DRC Meeting Minutes
Monday, March 21, 2022
Zoom (Remote) Meeting

Site Plan Review – Medway DPW Water Treatment Facility 19 Populatic Street

Subject: Populatic WTP – Proposed Storage Canopy – Supplemental Information

Subject: Medway WTP Draft Final Plan Review

Front View

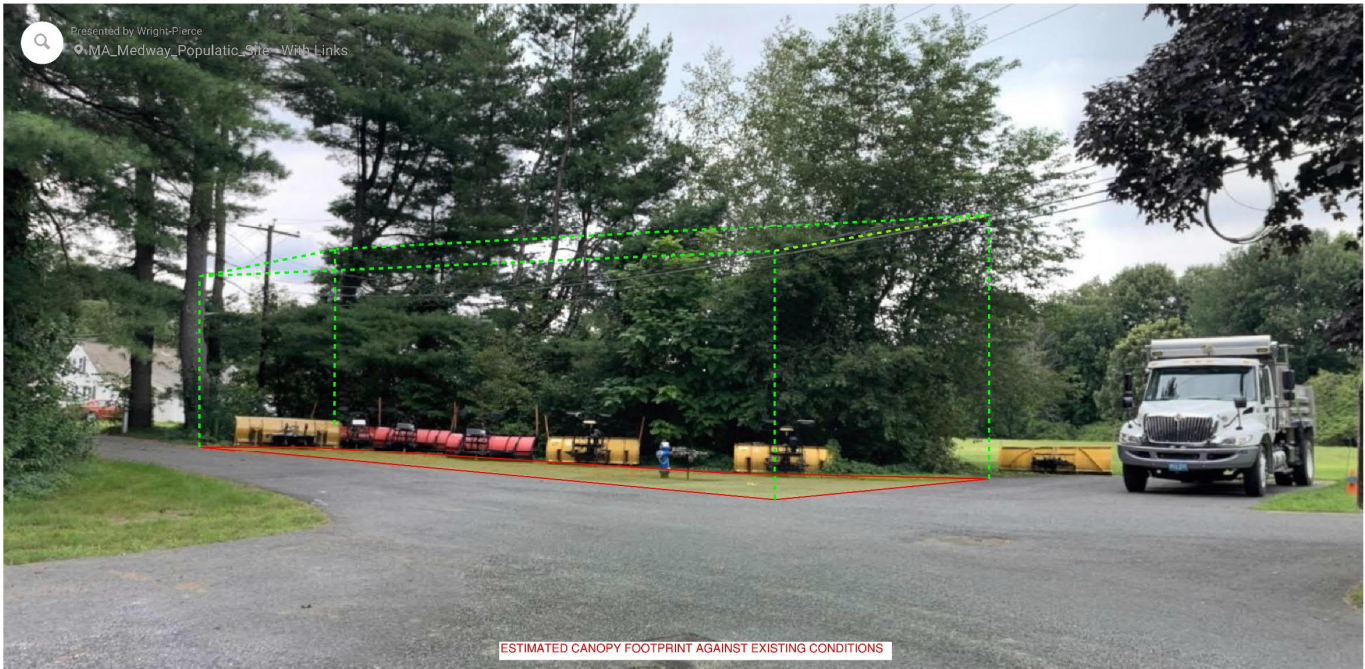
With respect to colors, there's not a lot of components to the canopy where colors would need to be selected for. We are currently proposing the steel framing to be hot-dipped galvanized because it's the most durable and requires little to no maintenance. The EPDM membrane roof we typically go with black, but could also go with white or gray, however it won't be that visible from the ground due to the low slope. There are some color options for the roof edge trim, but if we keep the galvanized steel, we would probably just go with a gray for the trim. But there are other options available – below is sample color chart from the company we specified around. As I've noted before during these meetings, the final colors on the project are not selected until construction starts and we receive the submittals so a decision doesn't need to be made next week on the colors.

3. We recommend the PEDB confirm with Design Review Committee that the proposed canopy structure has been reviewed and approved. (VIII.D.2) **JEC: We still owe the DRC some additional photos showing similar canopy structures so they can get a better visual of what the proposed canopy will look like once completed.**

DRAWING
C-6

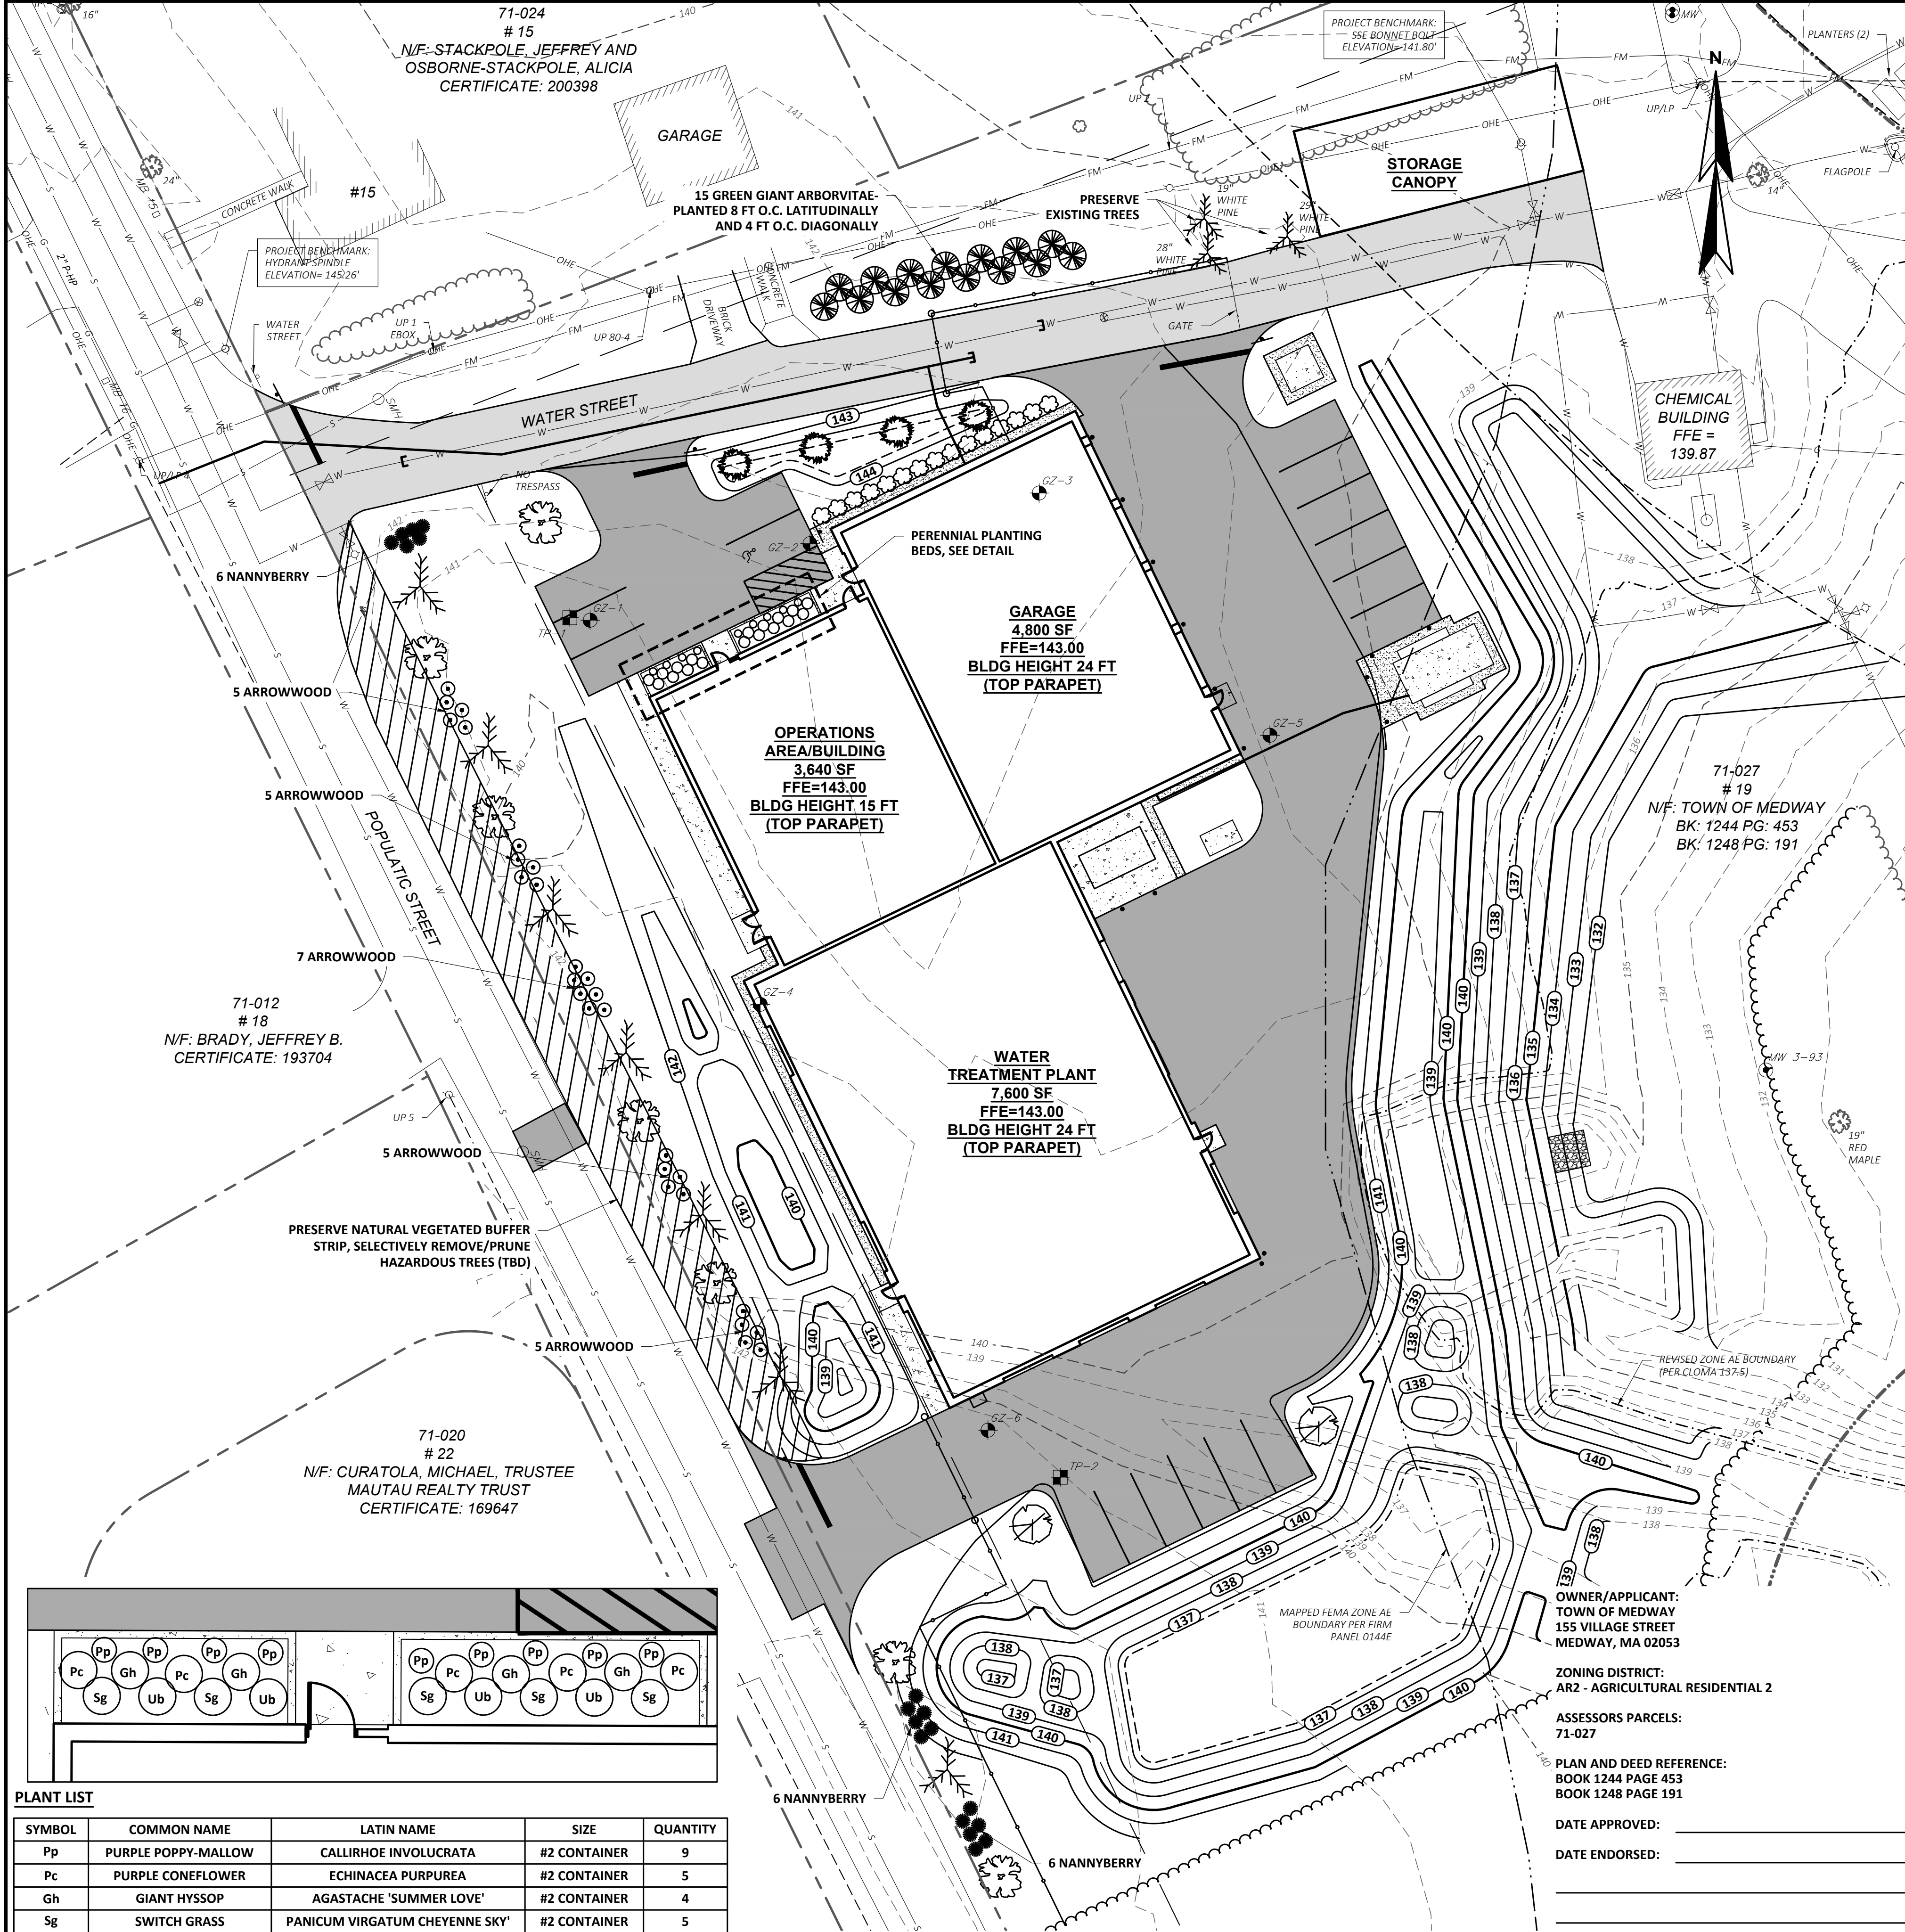
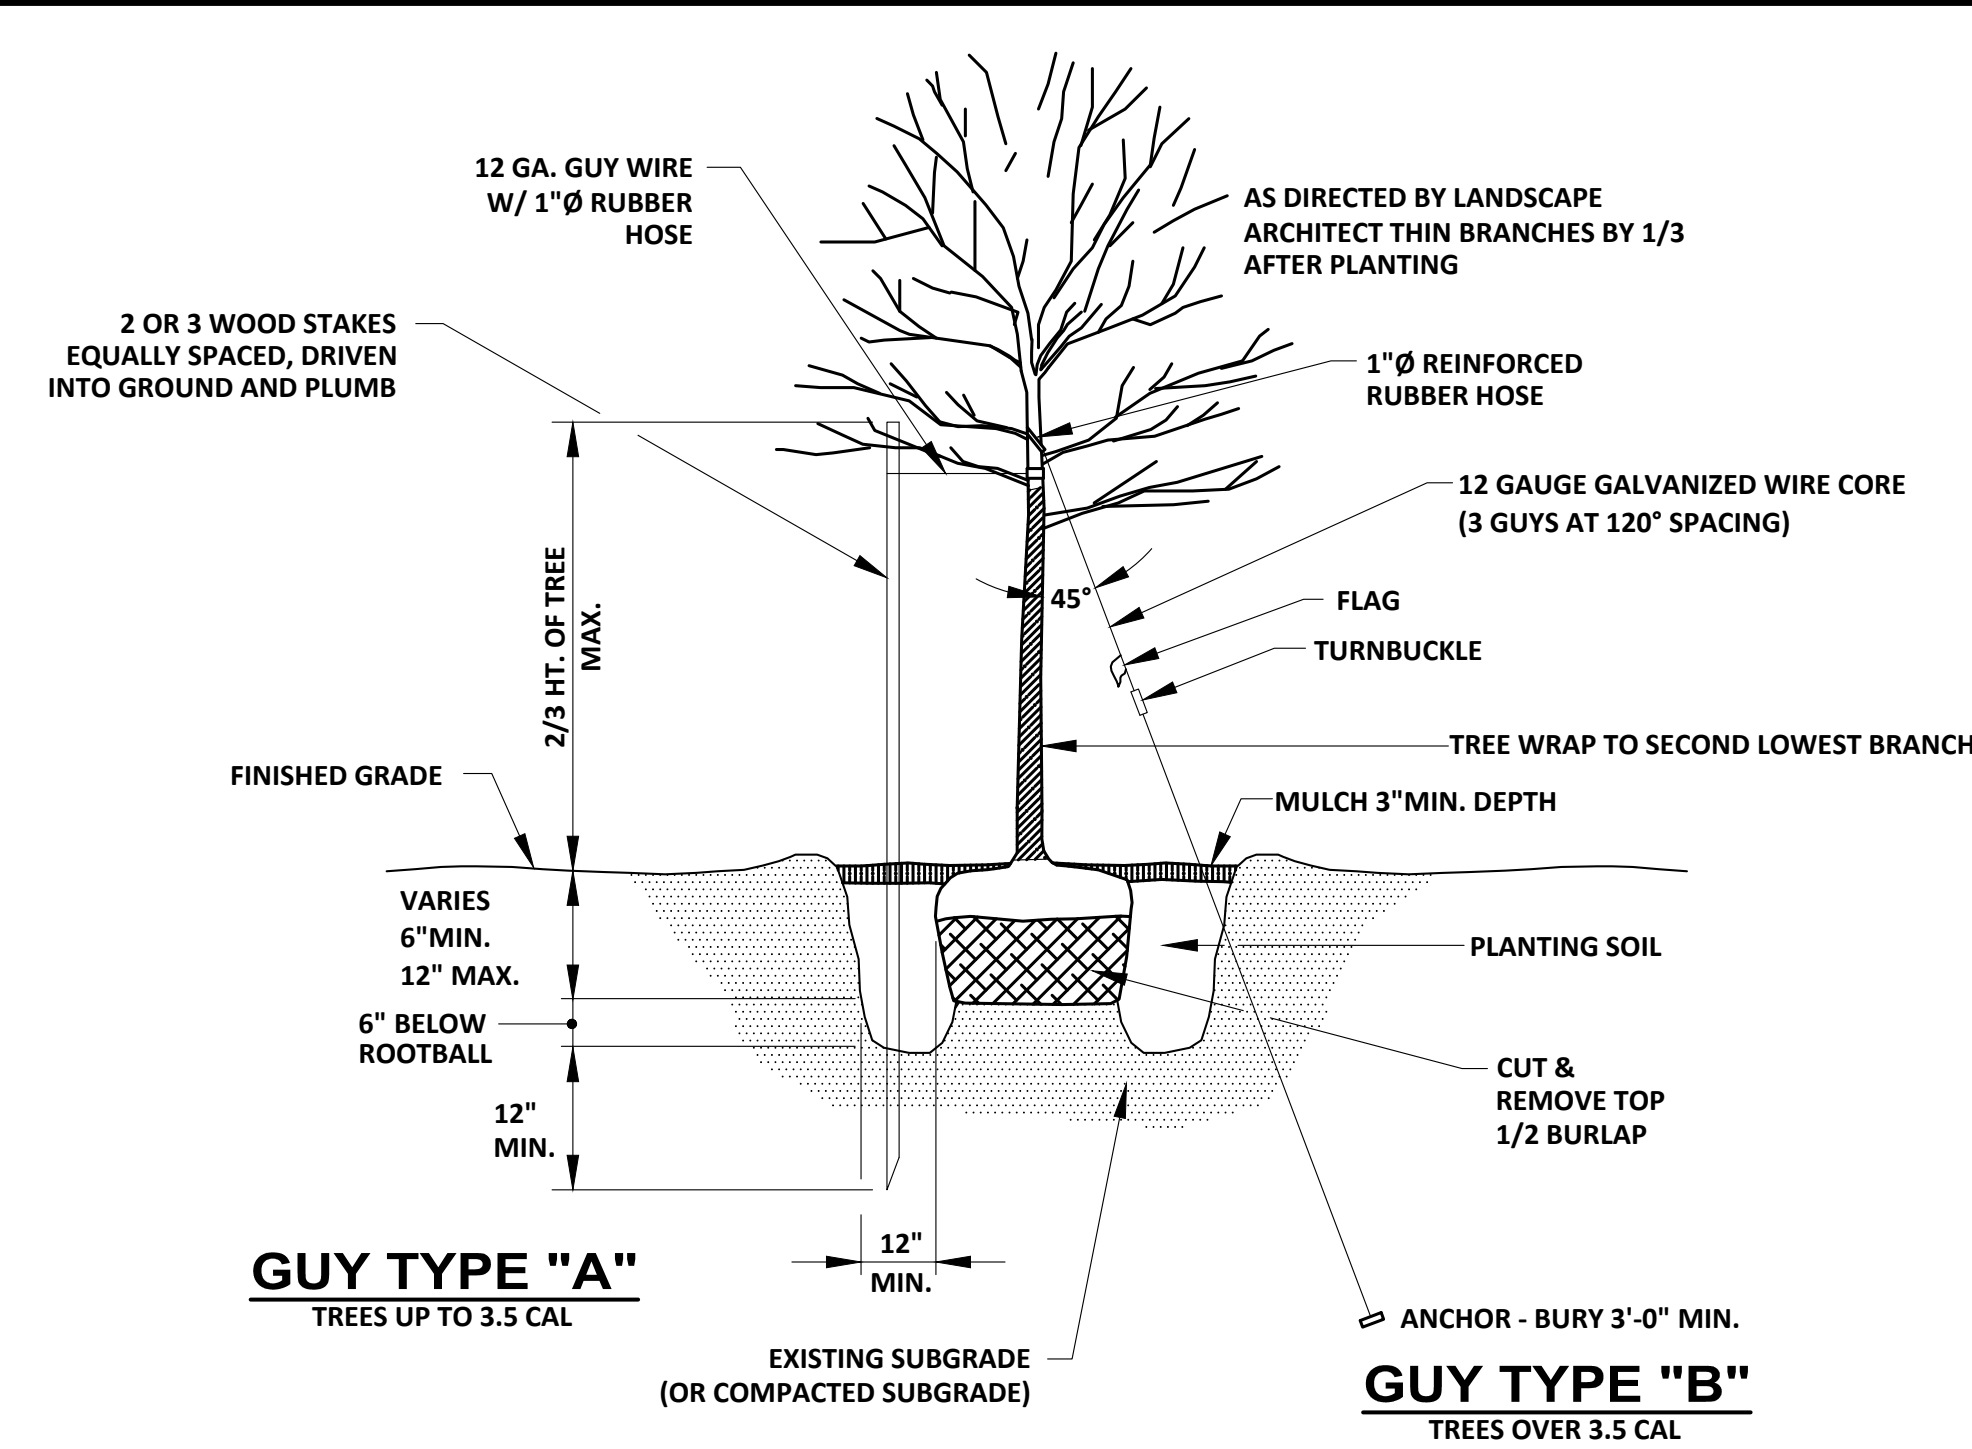
4. It does not appear additional landscaping is proposed to screen the Storage Canopy location as compared to the previous Plan Set. (VIII.D.7) **JEC: We discussed adding more landscaping to screen the canopy with our landscape architect. We were having a hard time determining what additional landscaping would really be needed. The goal was to screen the canopy from the abutting neighbor (#15 Populatic) as best we could and what we are showing now for screening appears adequate. There is not a lot open space to add additional plantings along that side of Water Street. We are keeping 3 large existing pines in place that already provide significant screening and we are also keeping the existing vegetation behind the proposed structure. So it's essentially surrounded by vegetation/screening. We also added a row of 15 Arborvitae to provide even more additional screening. See below. What is the PEDB's expectation for screening? We can certainly add more if needed, we just need some direction on where/what they would like added.**
